Access Compliance Report Public Rights-of-Way (Curb Ramps)

Main Street: KITTRICK_DR Cross Street: DONOVAN_RD Location: N

ADA ID: RPAT211202085924 Ramp Type: Type 1 - Perpendicular Diagonal Initial Pass/Fail: Fail Overall Compliance: No Severity Score: 2

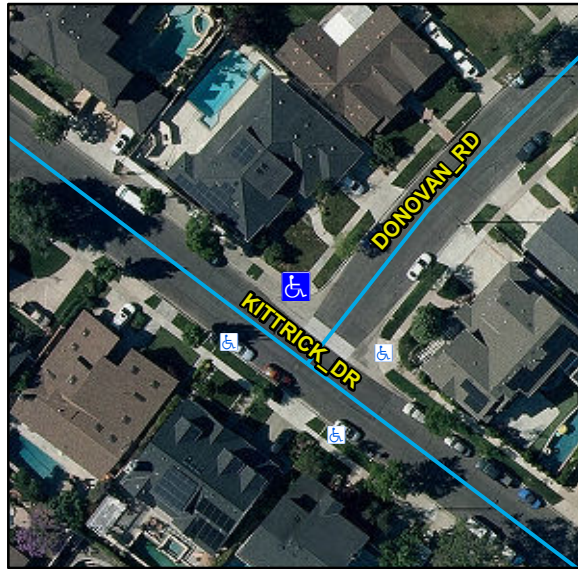
Compliance	Description	Data	Compliance	Description	Data
N/A	Ramp Length (in)	83	N/A	Flare Type LT	
Yes	Ramp Width (in)	48			N/A
Yes	Ramp Run Slope (%)	8.2	N/A	Flare Slope LT (%)	N/A
No	Ramp Cross Slope (%)	2.7	N/A	Flare Traversable LT	N/A
N/A	Landing Present	N/A	N/A	Flare Type RT	
N/A	Landing Length (in)	N/A			N/A
N/A	Landing Width (in)	N/A	N/A	Flare Slope RT (%)	N/A
N/A	Landing Run Slope (%)	N/A	N/A	Flare Traversable RT	N/A
N/A	Landing Cross Slope (%)	N/A	N/A	DWS Provided	N/A
N/A	Landing Movement Obstructed?	N/A	N/A	DWS Contrast	N/A
	Landing Movement Type	N/A	N/A	DWS Length (in)	N/A
N/A	Landing Shared	N/A	N/A	DWS Full Width	N/A
N/A	Clear Space	Yes	N/A	DWS Offset Left (in)	N/A
N/A	Clear Space To Crosswalk (in)	N/A	N/A	DWS Offset Right (in)	N/A
N/A	Marked Crosswalk 1	No	N/A	Marked Crosswalk 2	No
	Crossing 1 Direction	SW		Crossing 2 Direction	SE
	Marked Crosswalk 1 Width (in)	N/A		Marked Crosswalk 2 Width (in)	N/A

N/A	Ramp Inside Crosswalk 1	N/A	Yes	Ramp Inside Crosswalk 2	N/A
	Crossing 1 Slope (%)	6.1		Crossing 2 Slope (%)	3.9
	Crossing 1 Cross Slope (%)	1		Crossing 2 Cross Slope (%)	2.4
N/A	Gutter Ponding	N/A	No	Curb Slope	7.9
Yes	Gutter Lip Height (in)	0		Road Run Slope (%)	1.6
N/A	Gutter Run Slope (%)	N/A		Road Cross Slope (%)	0.2
N/A	Gutter Cross Slope (%)	N/A			
Yes	Overall Surface Condition: Acceptable		No	Perp Joint Present	No
	Cross Gutter Present?	Yes		Spandrel Present?	Yes
	Replace Cross Gutter?	No		Replace Spandrel?	No

Remove & Replace Curb Ramp With Two New Directional Ramps or Equivalent.

R304.2.2, R204.3, R304.5.3, STD 1115
